Access Compliance Report Public Rights-of-Way (Curb Ramps)

Intersection ID: 21011Main Street: CORONATION_BVCross Street: SARDIS_RD_NORTHLocation:WADA ID: 673A6918E613Ramp Type: PerpInitial Pass/Fail: FailOverall Compliance: NoSeverity Score: 61.25

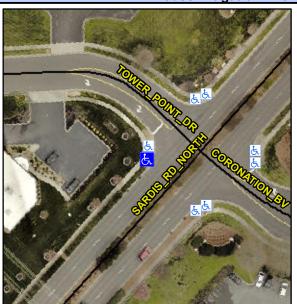
Not Found, R304.5.1, R304.2.2, R304.5.3, R302.7

Field Measurements/Component Compliance									
Comp	liance Description	Data	Comp	liance	Description	Data			
N/A	Ramp Length (in)	62.0	No	Ramp	Slope (%)	12.1			
No	Ramp Width (in)	37.0	No	No Ramp XSlope (%)					
N/A	Flare Type LT	N/A	N/A	N/A Flare Type RT		N/A			
N/A	Flare Slope LT (%)	N/A	N/A	N/A Flare Slope RT (%)					
N/A	Flare Traversable LT?	N/A	N/A	Flare	Traversable RT?	N/A			
N/A	Landing Length (in)	N/A	N/A	DWS	Provided?	N/A			
N/A	Landing Width (in)	N/A	N/A	DWS	Contrast?	N/A			
N/A	Landing Slope (%)	N/A	N/A	DWS	Length (in)	N/A			
N/A	Landing X Slope (%)	N/A	N/A	DWS	Full Width?	N/A			
N/A	Landing Curb? (Y/N)	N/A	N/A	DWS	Offset (in)	N/A			
N/A	Shared Landing?	N/A							
N/A	Gutter Ponding?	N/A	N/A	Gutte	r Slope (%)	N/A			
N/A	Gutter Lip Ht (in)	N/A	N/A	Gutte	r X Slope (%)	N/A			
N/A	Painted X Walk1?	No	N/A	Painte	ed X Walk2?	N/A			
	X Walk 1 Direction	To SE		X Wa	lk 2 Direction	N/A			
N/A	X Walk 1 Width (in)	N/A	N/A	X Wa	lk 2 Width (in)	N/A

X Walk 1 Slope (%)	2.5		X Wa	lk 2 Slope (%)	N/A			
	X Walk 1 X Slope (%)	5.1		X Wa	lk 2 X Slope (%)	N/A			
N/A	Ramp inside XWalk1?	N/A	N/A	Ramp	inside XWalk2?	N/A			
	Road Slope (%)	N/A	N/A	Clear	Space?	N/A			
	Road X Slope (%)	N/A	N/A	Clear	Space to XWalk (in)	N/A			
N/A	Any Obstructions?	N/A	N/A	Storm	Grate/Utility Hazard?	N/A			
	Obstruction Type			Storm	Grate/Utility Type				
		N/A				N/A			
			No	Surfa	ce Condition? (G/P)	Poor

Remove & Replace Entire Ramp.
